Type <b>Coffee Vending Machine</b>	Model <b>9100 IN - 9200 CV</b>	N° T.I. <b>03 - 2020</b>
Serial Number <b>00721964</b>	Subject <b>INSTANT BOILER ASSEMBLY MODIFICATIONS</b>	ISSUED FOR (X) Action Information <input checked="" type="checkbox"/>

**Modification 1**

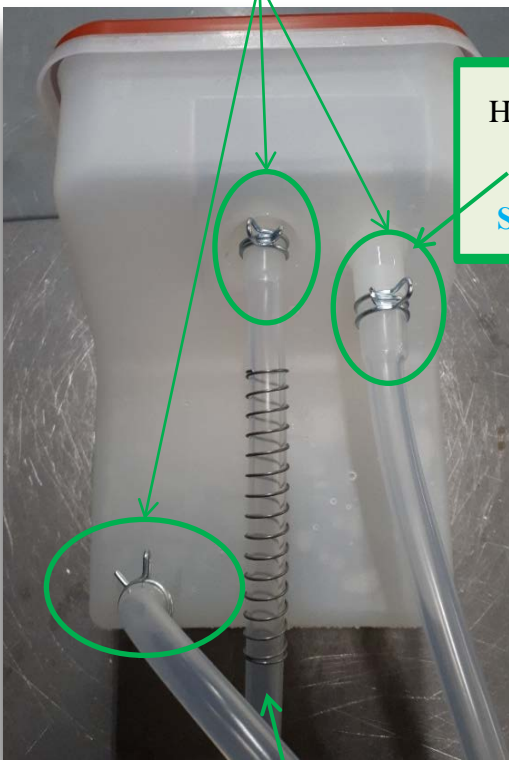
- Three hose clips** have been added on the hoses coming out from the instant boiler
- The pre-modification brown silicone hose**, connecting the instant boiler to the pump, has been replaced by a transparent silicone hose, plus a fitting and a shorter brown silicone hose.

boiler body + 3 hoses + **3 hose clips**

No hose clips

Hose clip Spare:

**096264**

**SAP 55114073**

**Modification 2**

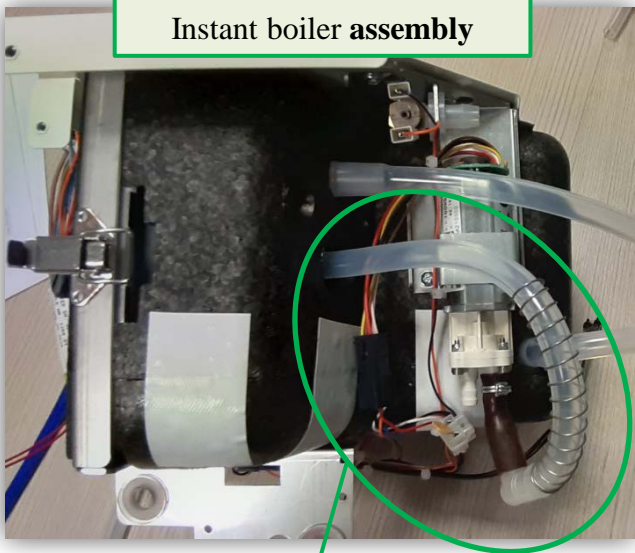
**Transparent silicone hose**  
replacing the **brown one**

**Pre-modification brown silicone hose**

Length: **260 mm** Spare: **255541**  
**SAP: 55100922**

**New solution**  
Instant boiler assembly

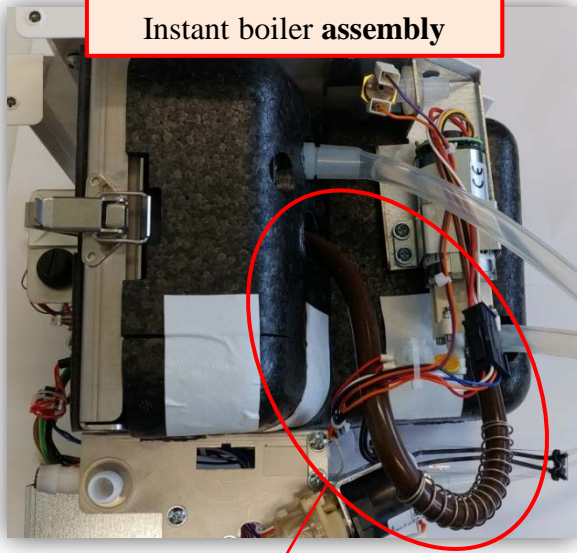
**Pre-modification solution**  
Instant boiler assembly

The instant boiler assembly spare code is not changed: **260784**

**Modification 2**

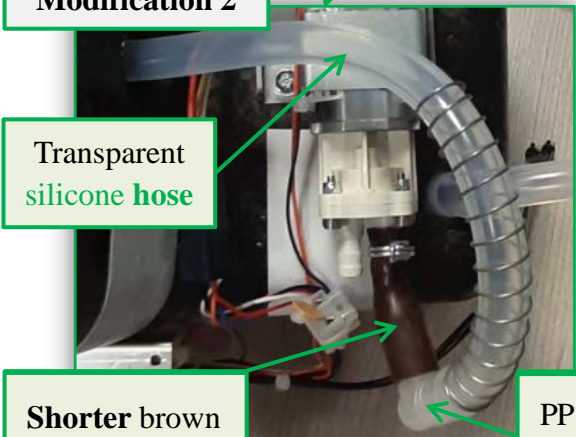
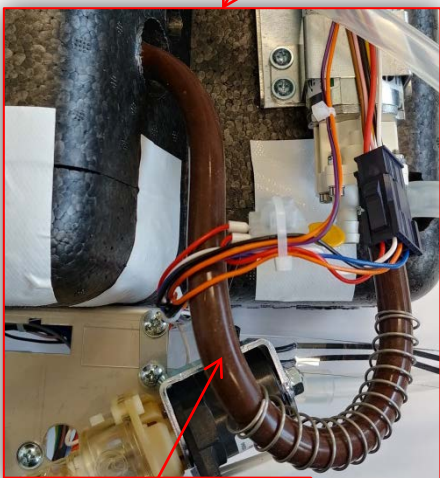
Transparent silicone hose

Pre-modification brown silicone hose

Shorter brown silicone hose (40 mm)  
Spare: **097685**  
SAP: **55001674**

PP elbow fitting  
Spare: **39758800**  
SAP: **55102011**
